UNITED STATES
DEPARTMENT OF THE INTERIOR
BUREAU OF LAND MANAGEMENTFORM APPROVED
OMB NO. 1004-0137
Expires: January 31, 2018**SUNDRY NOTICES AND REPORTS ON WELLS**
*Do not use this form for proposals to drill or to re-enter an abandoned well. Use form 3160-3 (APD) for such proposals.*5. Lease Serial No.
Multiple--See Attached
6. If Indian, Allottee or Tribe Name**SUBMIT IN TRIPLICATE - Other instructions on page 2**7. If Unit or CA/Agreement, Name and/or No.
Multiple--See Attached

OXY USA Inc. respectfully requests the following bulk sundry changes to the approved APD's for the following wells:

1. Oxbow CC 17-8 Federal Com #34H - 30-015-45086
2. Oxbow CC 17-8 Federal Com #35H - 30-015-45087
3. Oxbow CC 17-8 Federal Com #36H - 30-015-45088

OXY USA Inc. – Oxbow CC 17-08 Federal Com 34H-35H-36H – Amended Drill Plan

5/10M BOP Stack

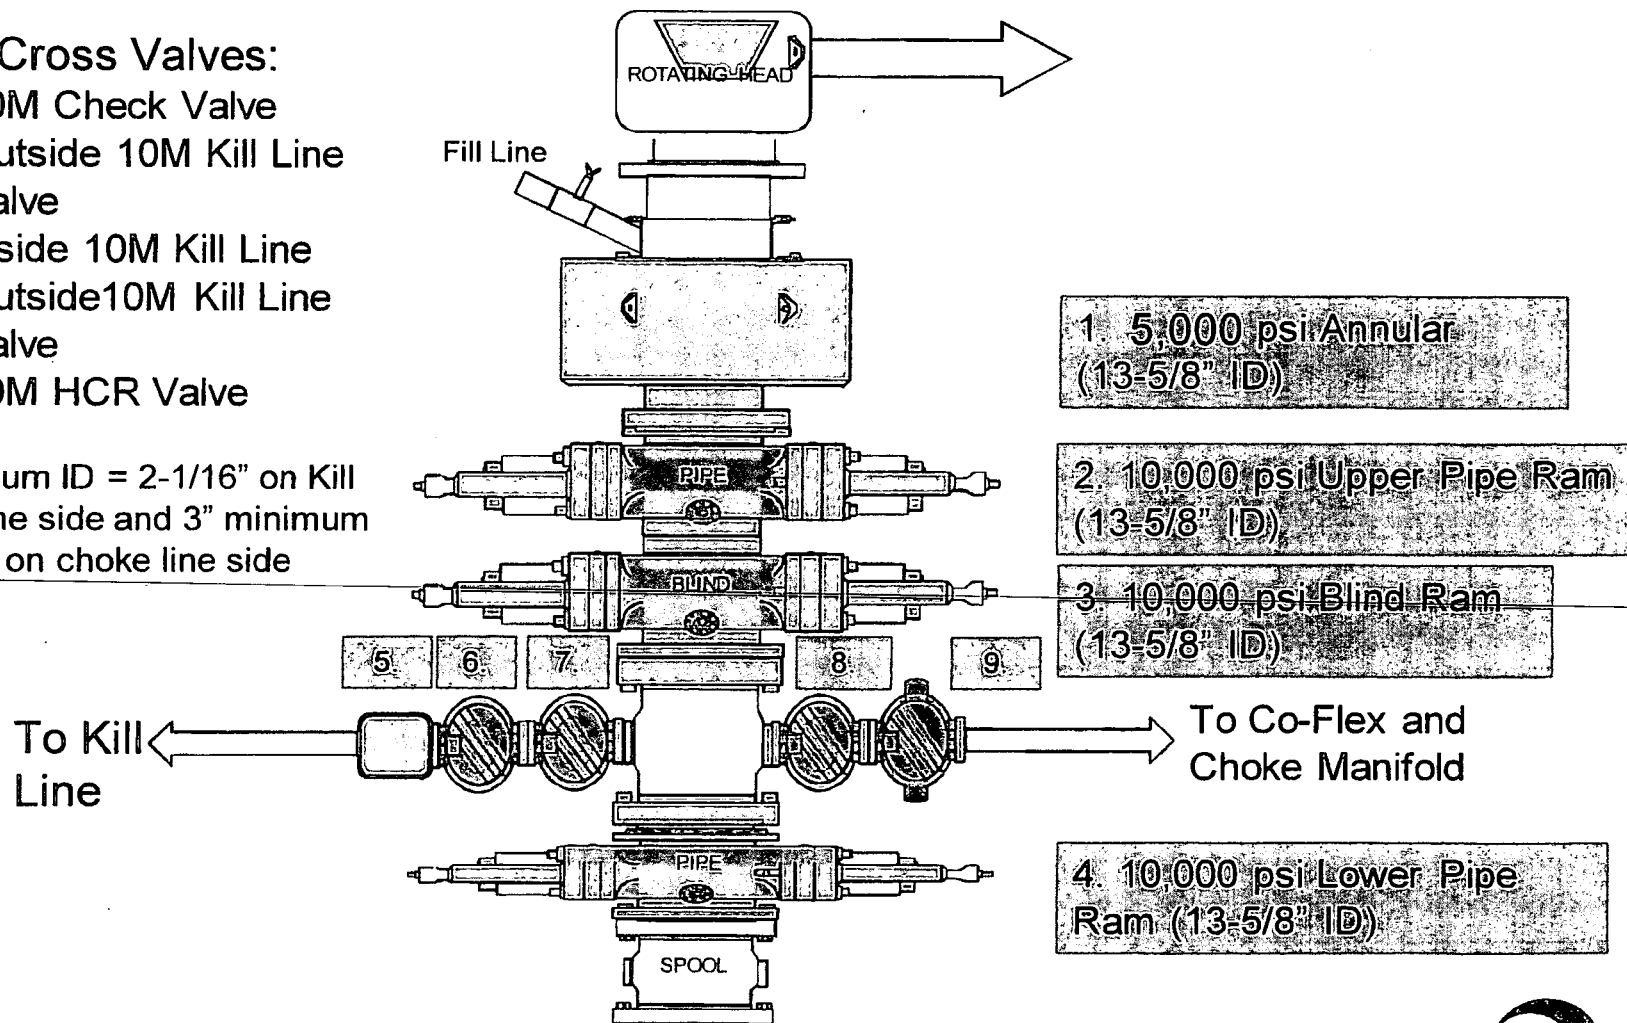
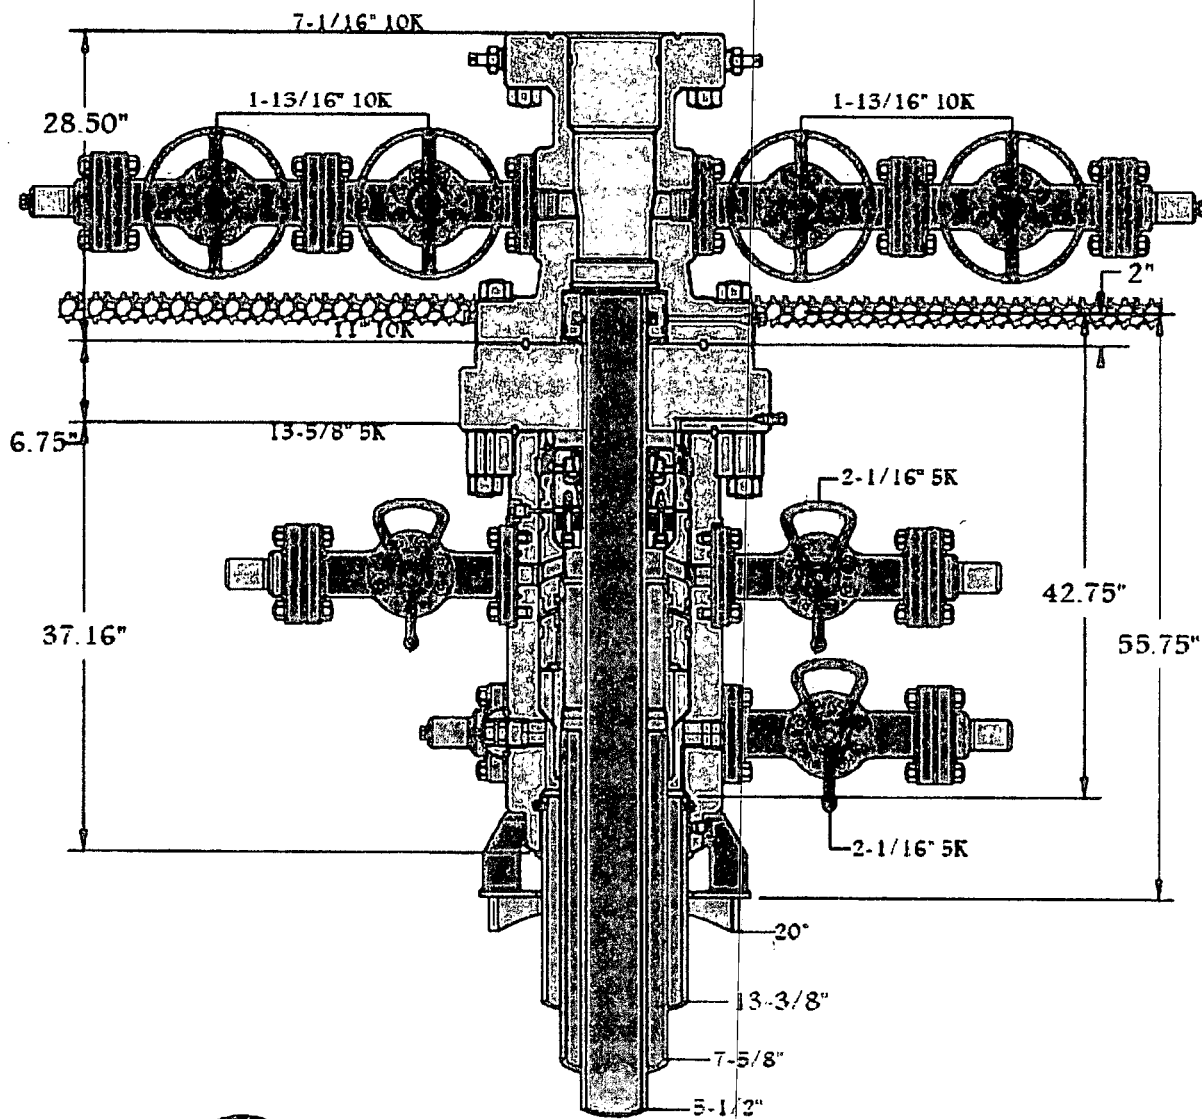
- requirement.
3. Request Offline Intermediate Casing/Cementing Variance, see attached.
4. Update BOP Break Testing Request, Information and Plan
5. Update BOP/Wellhead Diagram

OXY will utilize a 5M annular with a 10M BOPE stack. The BOP/BOPE will be tested by an independent service company to 250 psi low and the high pressure indicated above per Onshore Order 2 requirements. The System may be upgraded to a higher pressure but still tested to the working pressure listed in the table above. If the system is upgraded all the components installed will be functional and tested.

5 1/2" 20# P110 DQX Tie-back string specifications:

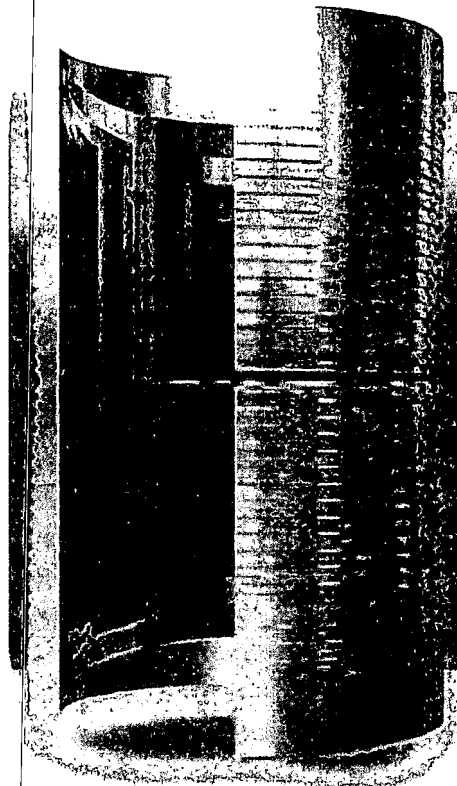
1. Change Production Casing to Liner and update cementing information. See attached for Casing Tie Back Detail
2. Request Bradenhead squeeze for the 2nd stage Intermediate casing with the Bradenhead CBL

1. OXY is requesting permission to have minimum fill of cement behind the 5-1/2" production liner to be 100' into previous casing string. The reason for this is so that we can come back and develop shallower benches from the same 7-5/8" mainbore in the future.
2. Our plan is to use a whipstock for our exit through the mainbore. Based on our lateral target, we are planning a whipstock cased/hole exit so that kick-off point will allow for roughly 10deg/100' doglegs needed for the curve.
3. Cement will be brought to the top of this liner hanger.
4. See attached for additional casing tie-back information.

- Cement should tie-back **100 feet** into the previous casing. Operator shall provide method of verification. **Excess calculates to 10% - additional cement might be required.**
